RE: Mubarak Villa, Response to City comments, 2nd submittal  
Application Number: DA-2171-00  
Case Number: 2019-4004-00

The following text in light grey contains COA comments taken directly from the City's letter dated 9/12/19. The text in black, following each comment, is Prism's response.

Plat

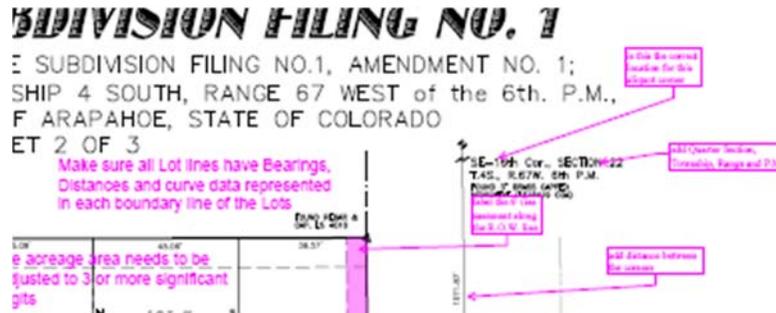
12H. Revise sheets to meet Arapahoe County requirements: 24 x 36-inch sheets with a 2-inch left margin and ½ inch margins on all other sides.

**This has been updated.**

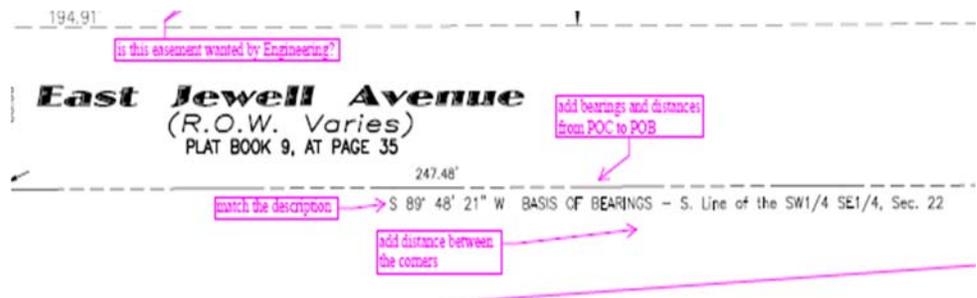
Certain comments which are specific as to the practice of land surveying and are in direct conflict with industry standard practices, our professional liability and licensure as a professional land surveyor may not be fully addressed as commented on by city staff. Every effort has been made however to address the comments as much as possible. Here are a few examples:

All lot lines have bearings and distances that are tied to other controlling lines and corners. Adding redundant bearings creates confusion, makes plans unreadable, and does not meet with industry standards. Also, we have identified, as shown above, we have identified quarter sections, townships, ranges and Principal Meridians where requested.
